Comments received during the 30-day public consultation (from 12 March 2023 until 11 April 2023) on the Environmental Impact Assessment (EIA) Report and Appropriate Assessment (AA) Report for:

PA/07254/22 (EA/00002/22) - Proposed iconic Tourism Complex with a different layout from that approved in permission PA/2478/16. The proposed amendments comprise clusters of serviced apartments [789 in total] with dedicated amenities, 2 Class 3B Hotels [124 Room Hotel & 132 Room Hotel], Class 4A Offices, a Multi-purpose Hall, Class 4B and 4C Retail Shops, Class 4D Food and Beverage facilities and 3 Levels of Parking Spaces. The proposed overall massing ranges from a low lying Hotel of 4 levels beneath street level to 2 iconic towers of 27 and 34 levels respectively. Site at, Villa Rosa, Cresta Quay, Dolphin House, Moynihan House, Triq Santu Wistin, ix-Xatt ta' San Gorg and, Triq id-Drangunara, San Giljan.

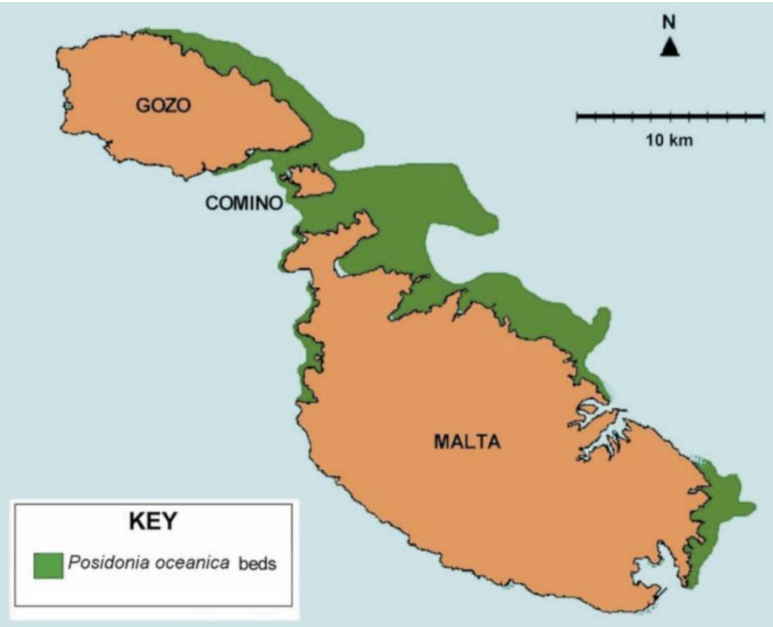
No	From	Comments
		<p>Although the EIA clearly states that vistas are going to be blocked from certain viewpoints, instead of condemning blocking of vistas, the EIA tries to justify such situation arising.</p> <p>It is worth mentioning that vistas are there for the enjoyment of all and not of the selected few and consequently steps must be undertaken to ensure that vistas are not obstructed by such large-scale development. This also in view that the density of the proposed development increased significantly from that approved in the previous planning application.</p> <p>8. Conclusion</p> <p>In view of the above, St. Julians Local Council reiterates its position that in view of similar large projects surrounding the proposal in question, it is advisable that the EIA prepared for the current proposal will be revised so that instead of taking into account the proposed project in isolation, the EIA should cover the whole area of.</p>
